# PRODUCT BULLETIN

**Bulletin No:** PB440  
**Issue Date:** 9-3-2019  
**Effective Date:** 10-1-2019

**Description/Title:**  
T31-xxBC1 Shape Change

**Part No:**  
T31-00BC1, T31-01BC1, T31-02BC1, T31-03BC1

**Specification:**  
**SPECIFICATION CHANGE**

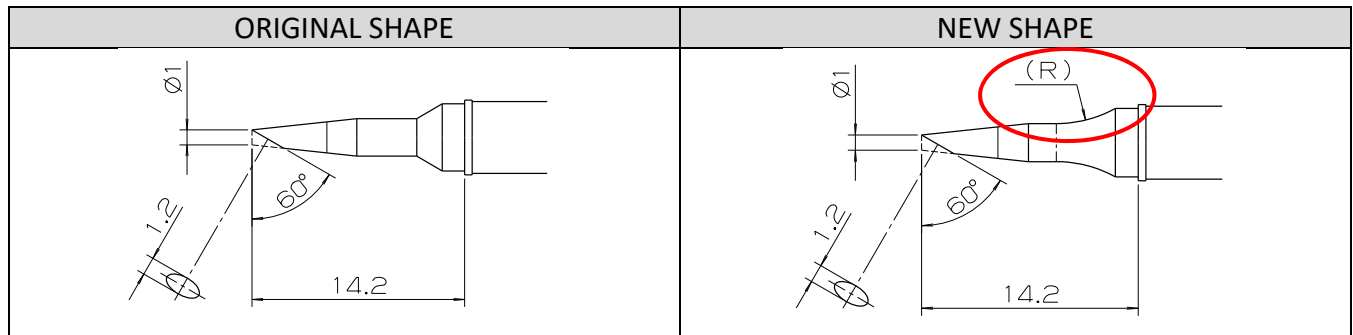
Hakko will be making a subtle change to the BC1 shape of T31 Series tips. This change (as shown in the diagram above) improves the heat transfer to the end of the tip by increasing the mass of the tip without affecting the reach and operator visibility.
